Wisconsin Department of Transportation

Proposal #31: 1430-01-73, WISC 2017 537
Point Bluff Bridge
Wisconsin River Bri B-29-141,-148
STH 82
Juneau and Adams Counties

This is Addendum No.01, which provides for the following:

ADDENDUM NO. 01
PROJECT ID 1430-01-73
November 7, 2017

Addendum No. 01
ID 1430-01-73
Revised Sheet 8
November 7, 2017

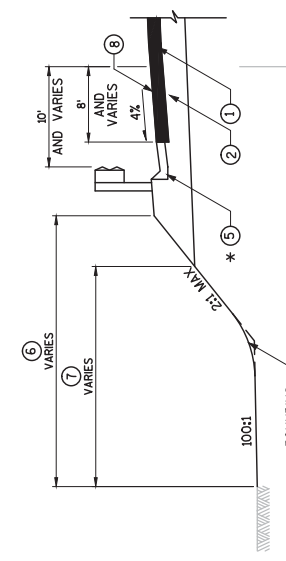
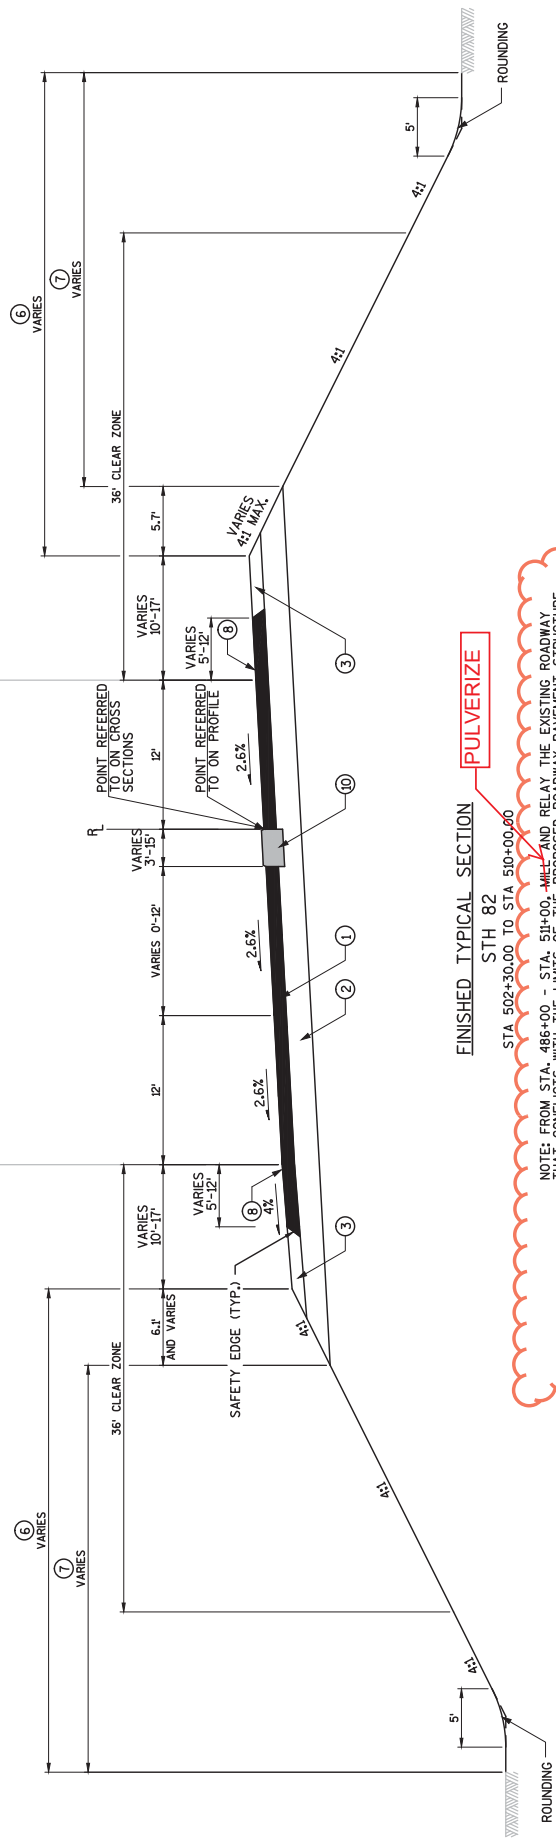
Revised Plan Sheets	
Plan Sheet	Plan Sheet Title (brief description of changes to sheet)
7, 8, and 11-14	Typical Sections (Defined rock excavation under pavement, change MILL to PULVERIZE)
22	Construction Detail – Waterway Marker (Changed note regarding buoys included in bid item)
25	Construction Details (Added second inlet at bridge ends)
65-67	Traffic Control (Change MILL to PULVERIZE)
114, 115	Miscellaneous Quantities (Revised Earthwork Table to make use of excavated rock more clear)
116, 118, 121	Miscellaneous Quantities (Revised various bid items and quantities)

NOTE: FROM STA. 486+00 - STA. 511+00 - AND RELAY THE EXISTING ROADWAY THAT CONFLICTS WITH THE LIMITS OF THE PROPOSED ROADWAY PAVEMENT STRUCTURE. ~~WILL OFF~~ THE EXISTING FULL DEPTH 5" OF HMA AND RELAY 4" ON TOP OF THE 8" OF EXISTING BASE AGGREGATE DENSE FOR A TOTAL OF 12" BASE AGGREGATE DENSE. MATERIAL GENERATED FROM EXISTING PAVEMENT SHALL BE USED AS BASE AGGREGATE DENSE. PAVE 6" OF HMA PAVEMENT, TYPE 4 MT 58-28 S.

Addendum No. 01
 ID 1430-01-73
 Revised Sheet 12
 November 7, 2017

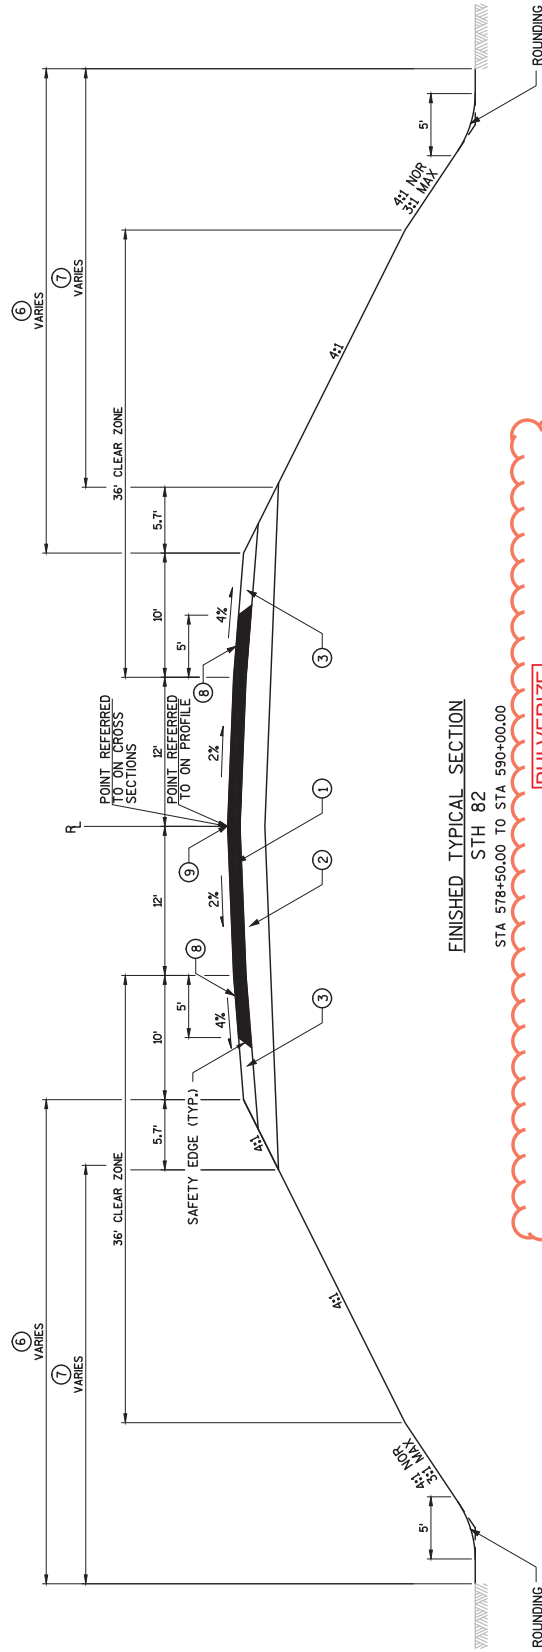
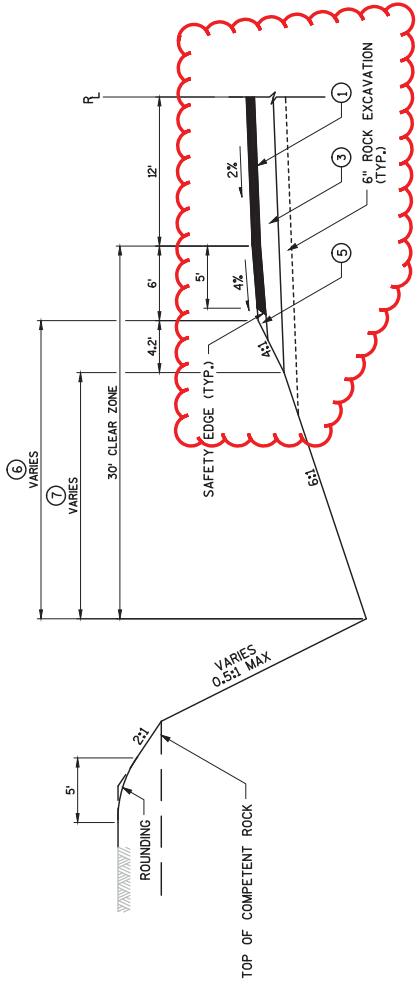
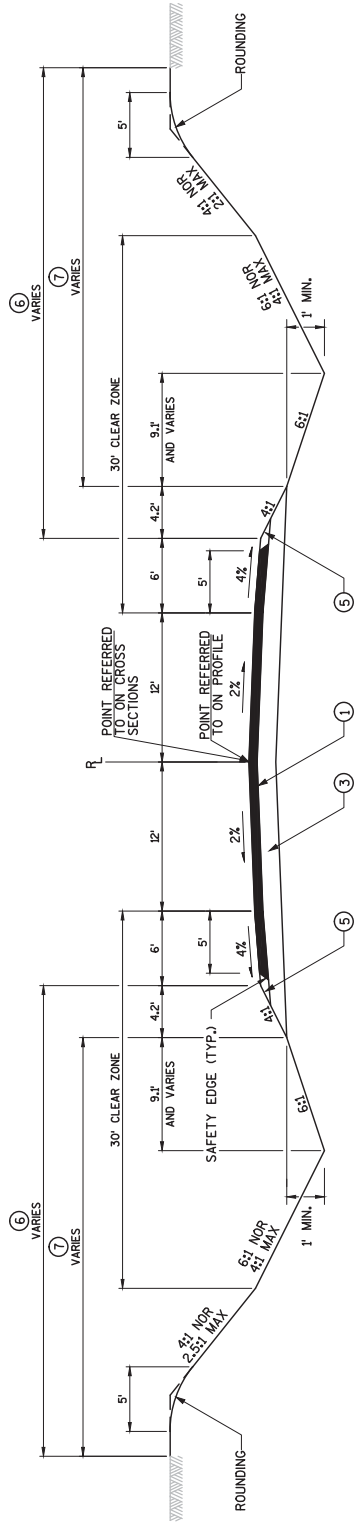
NOTE: FROM STA. 577+00 TO STA. 586+00, HMA AND RELAY THE EXISTING ROADWAY PAVEMENT TO THE EXISTING FULL DEPTH OF HMA AND RELAY 4" ON TOP OF THE 8" OF HMA OFF THE EXISTING FULL DEPTH OF HMA AND RELAY 4" ON TOP OF THE 8" OF EXISTING BASE AGGREGATE DENSE FOR A TOTAL OF 12" BASE AGGREGATE DENSE. MATERIAL GENERATED FROM EXTRA 1" OF MATERIAL SHALL BE USED AS BASE AGGREGATE DENSE. PAVE 6" OF HMA PAVEMENT, TYPE 4 MT 58-28 S.

FULL DEPTH RECONSTRUCTION REQUIRED FROM 586+00 TO MATCH INTO EXISTING AT 590+00

Addendum No. 01
ID 1430-01-73
Revised Sheet 22
November 7, 2017

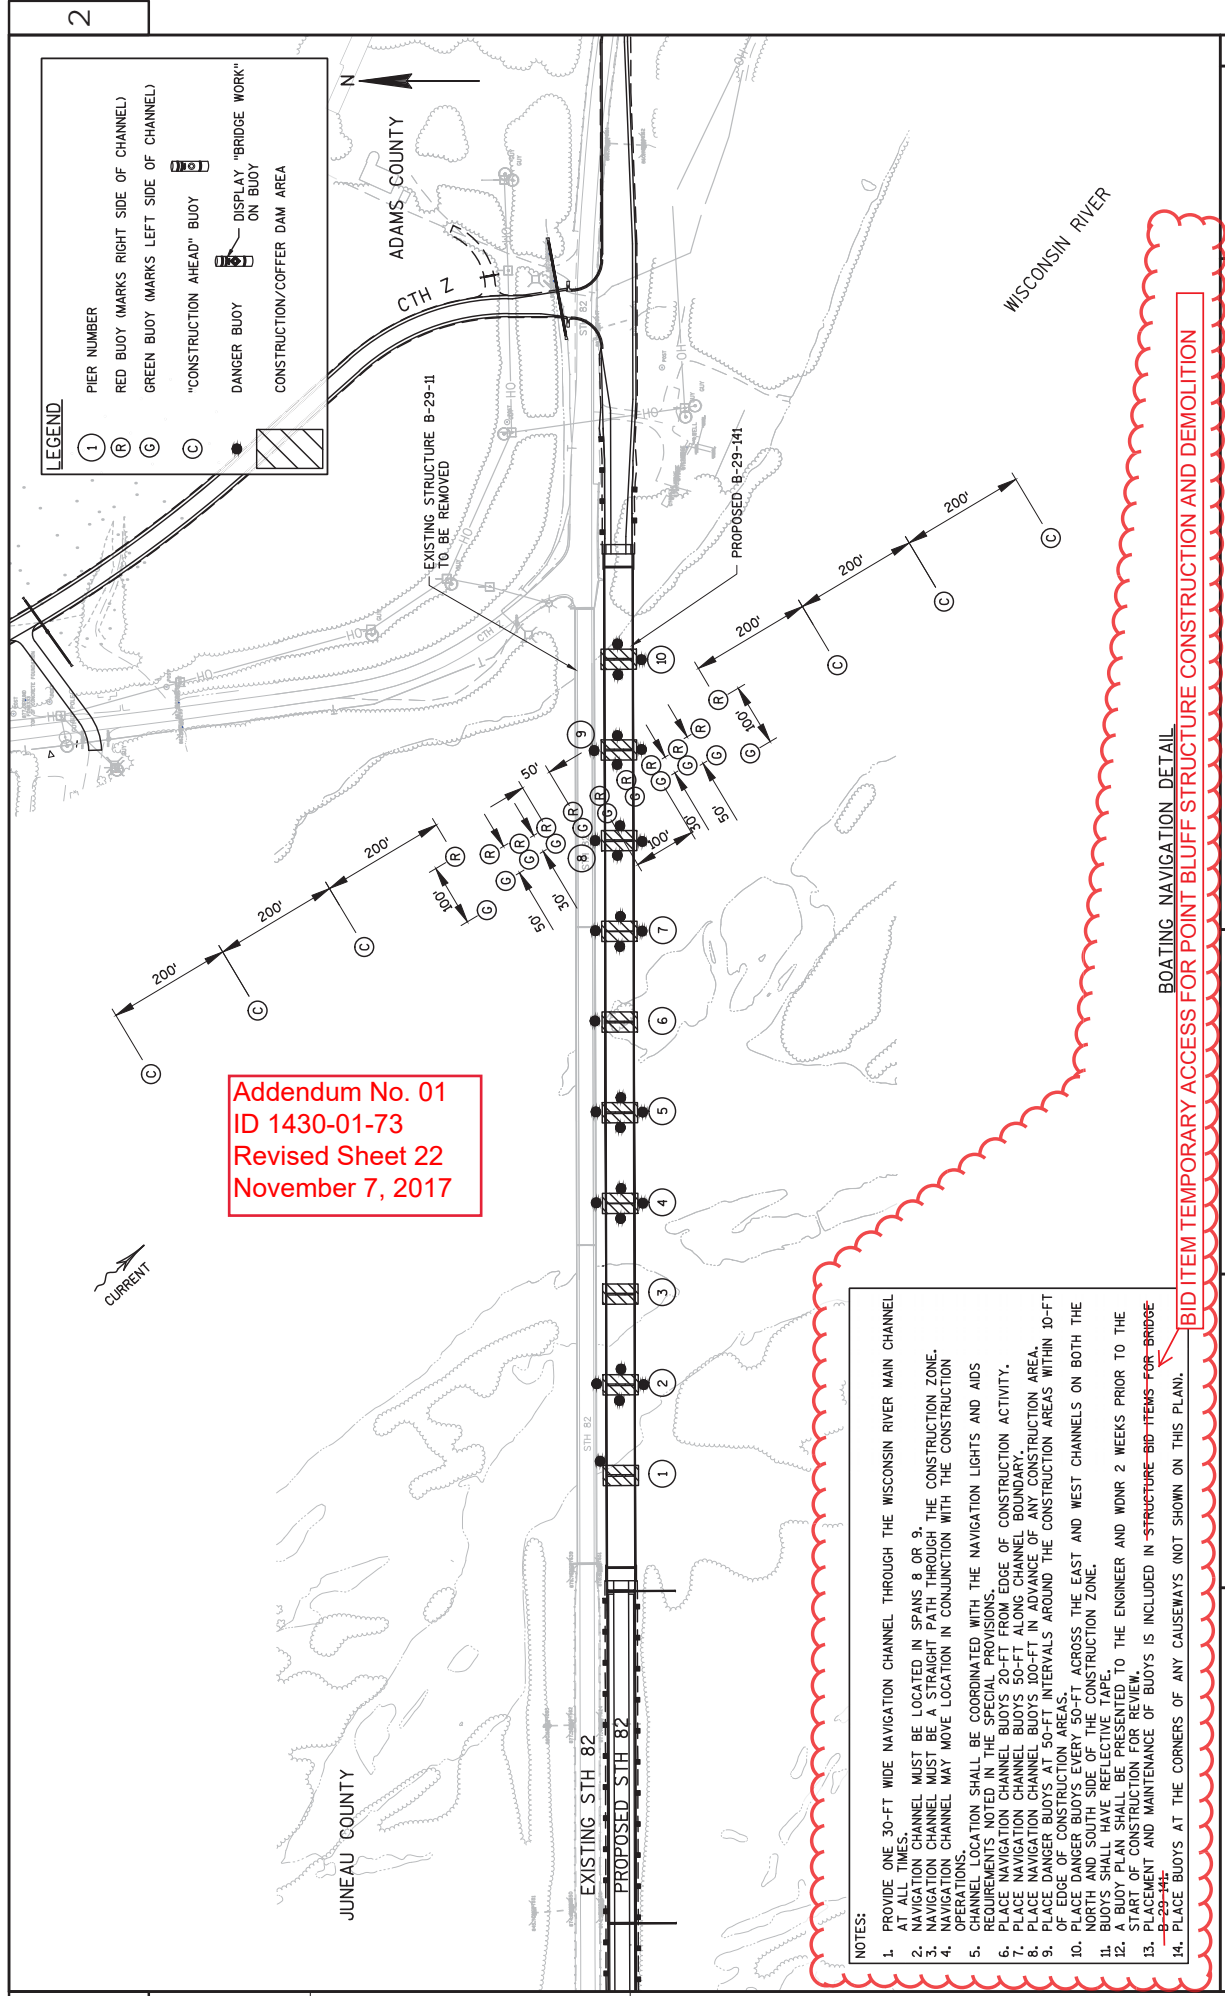
12. A BUOY PLAN SHALL BE PRESENTED TO THE ENGINEER AND WDMR 2 WEEKS PRIOR TO THE START OF CONSTRUCTION FOR REVIEW.
 13. PLACEMENT AND MAINTENANCE OF BUOYS IS INCLUDED IN STRUCTURE-BID-ITEMS-FOR-BRIDGE-B-29-141.

Addendum No. 01
 ID 1430-01-73
 Revised Sheet 65
 November 7, 2017

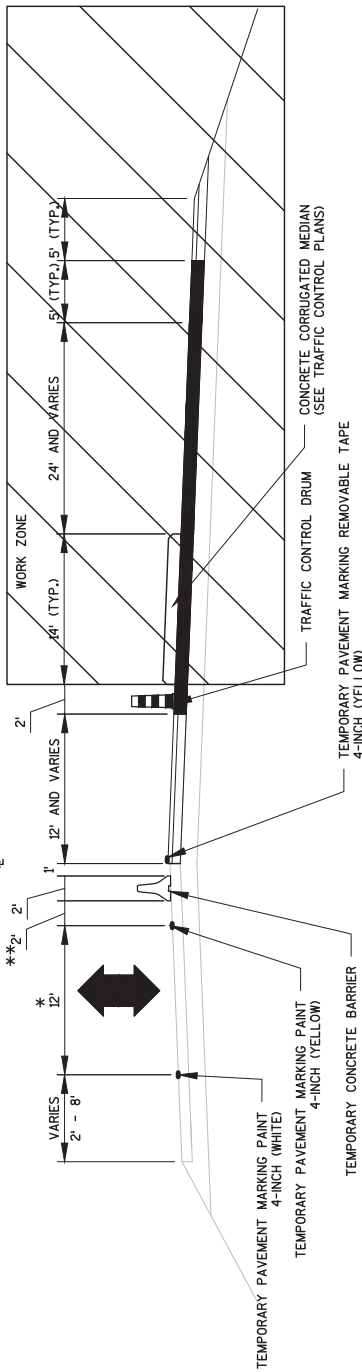
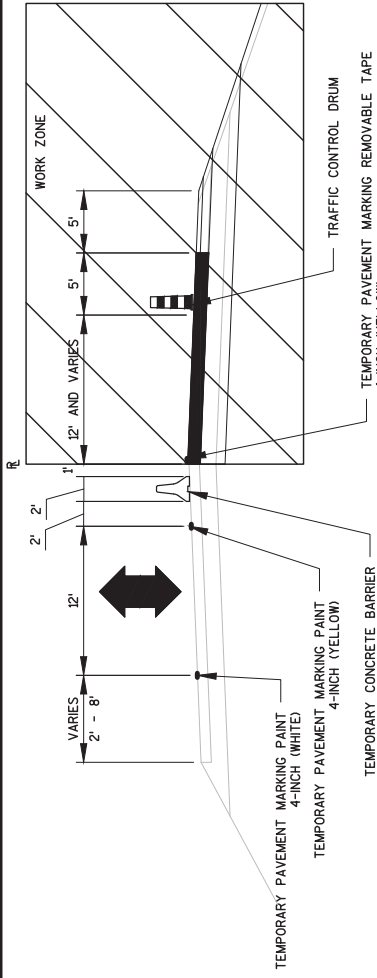
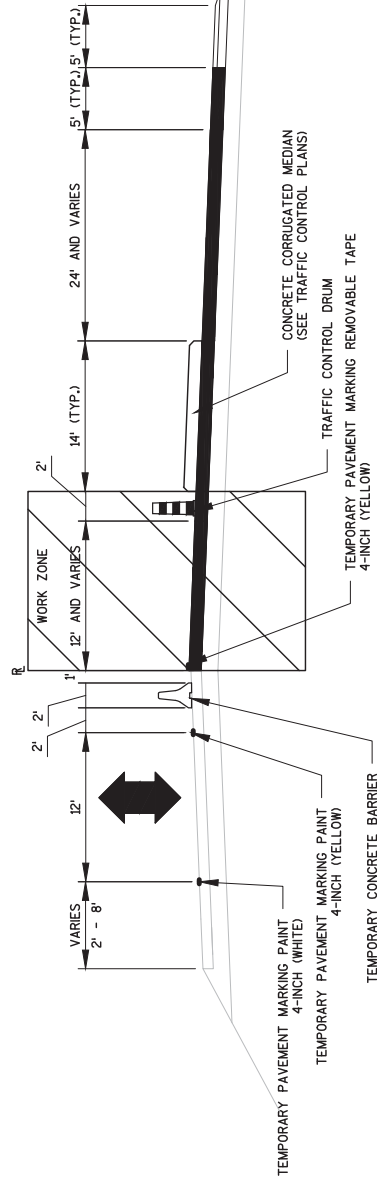
TRAFFIC: ONE LANE, FLAGGING OPERATION, DAYTIME ONLY
 CONSTRUCTION: ~~WHILE~~ EXISTING ASPHALT AND RELAY 4" AS BASE AGGREGATE.
 PLACE FIRST 2" LIFT OF HMA.
 CONSTRUCT CONCRETE CORRUGATED MEDIAN
 TEMPORARY PAVEMENT MARKING.

PULVERIZE
